**Subject: Response to Portion of NRC Request for Additional Information
Letter No. 34 – Support Systems – RAI Number 9.3-26**

**Partial Response to RAI Letter No. 34 Related to ESBWR
Design Certification Application.**

RAI Number 9.3-26

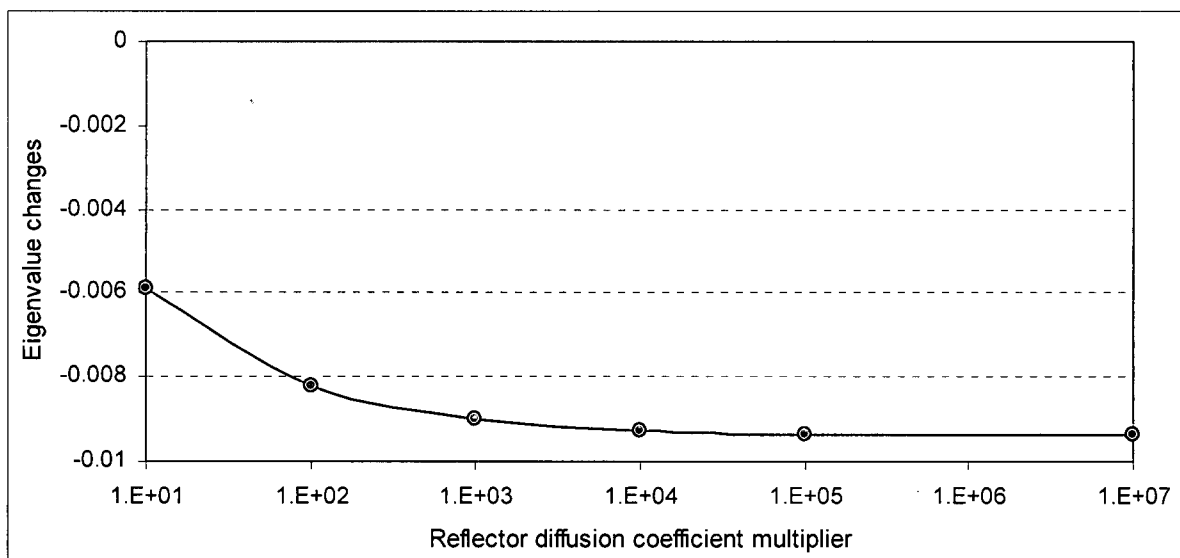
Provide the reactivity worth of the radial reflector (that is the bypass region surrounding the core, shroud, and annulus).

The Level 2 code PANACEA is used to evaluate the reactivity worth of the radial reflector by increasing artificially the leakage in the reflector region. This can be achieved in PANACEA by increasing the reflector diffusion coefficients in the three energy groups.

A steady-state case is initially run with “standard” reflector diffusion coefficients for the following conditions:

- EOC (End Of Cycle) : 16771 MWd/St
- Power : 4500 MWth (100% rated)
- Flow : 78.51 Mlb/hr (100% rated)
- Pressure : 1055 psia

In addition, six cases were run for the same conditions as described above with reflector diffusion coefficients increased by different orders of magnitude. The following figure displays the changes in the eigenvalue k_{eff} as a function of the multiplication coefficient.

As seen in the figure, changes in reactivity are always negative, as expected and tend to reach an asymptotic value, which is less than 0.01.

The reactivity worth of the radial reflector (that is the bypass region surrounding the core, shroud, and annulus) is approximately 1% Δk_{eff} (i.e. 1.75\$ if the reactivity is calculated as $\Delta k_{eff} / k_{eff} \beta$ where β is the total delayed neutron fraction).
